WARRANTY
CAMPAIGN

ROADSTER
WARRANTY
Bulletin

Campaign no.: 2013-0015
2013-0016

Subject: **Spyder™**

1. Old fuse box cover
2. New fuse box cover

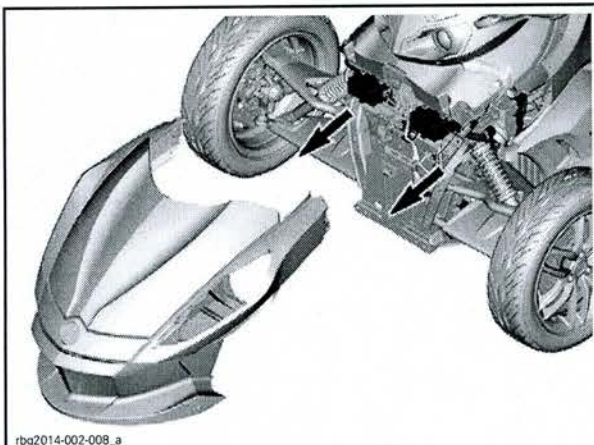
A - Seal the front fuse boxes

Water may infiltrate either of the front fuse boxes. The source of the infiltration may be:

1. The fuse box cover.
2. The bus-bar connection behind fuse box
3. Any of the wire splices behind fuse box.

1. Replace the fuse box covers.
2. Apply liquid tape around base of bus-bar.
3. Apply liquid tape into and around all splices behind fuse boxes.

1. Remove old covers.

2. Transfer fuses to new covers.

TYPICAL LIQUID TAPE APPLICATION

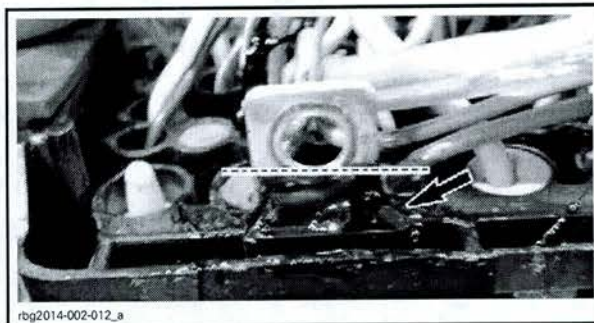
5. Seal both ends of all the wire splices with liquid tape.

NOTE: Extend liquid tape onto wires and push the liquid tape into both ends of the splice for a good seal.
